Product change notification

Tina 6A obsolescence

PCN Document No.	2TLC010040J0201	Date of PCN:	2022-09-07
PCN issued by:	Elias Agrell	PCN valid as of:	2022-09-07
Product Manager:	Gustav Örnstedt	Obsolescence Date:	2022-09-30
R&D Manager:	Peter Stegmaier	Change Date:	2022-09-30
Products impacted:	Tina 6A		
Impact on Form/Fit/Function:	[] Form [] Fit [] Fctn		Impact on reliability: [] Y [X] N

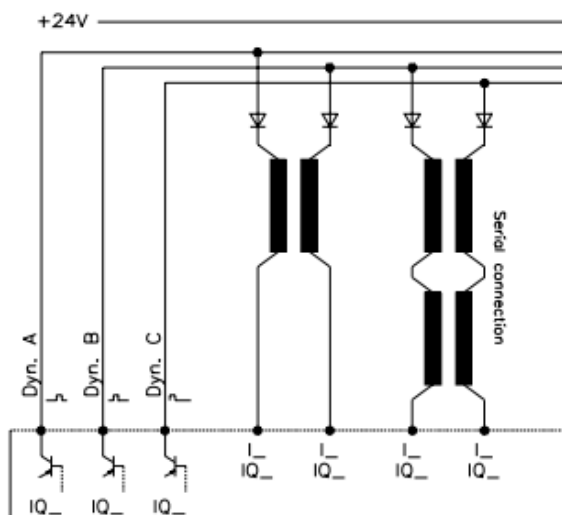
Obsolescence of Tina 6A.

Sentry USR: Use Sentry USR10 or USR22 according to Sentry manual page 21 (doc.no 2TLC010072M0201):

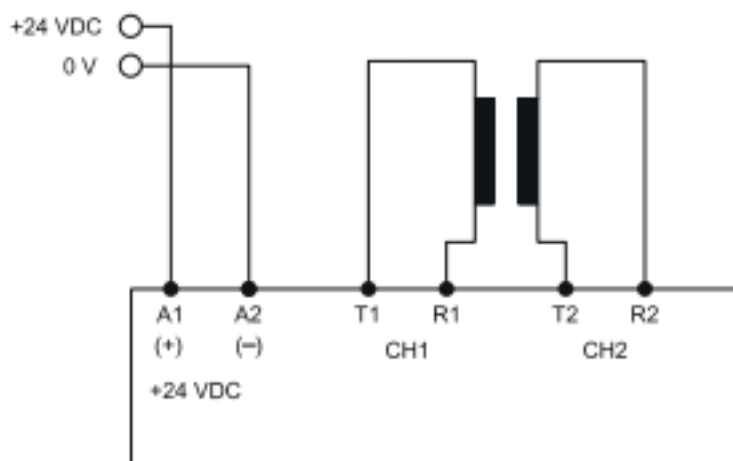
Both T1/R1 and T2/R2 safety inputs must be used for this function. An activated force on the pressure sensitive device will result in a short-circuit over T1/R1 and T2/R2. A short-circuit will inactivate the safety relay output.
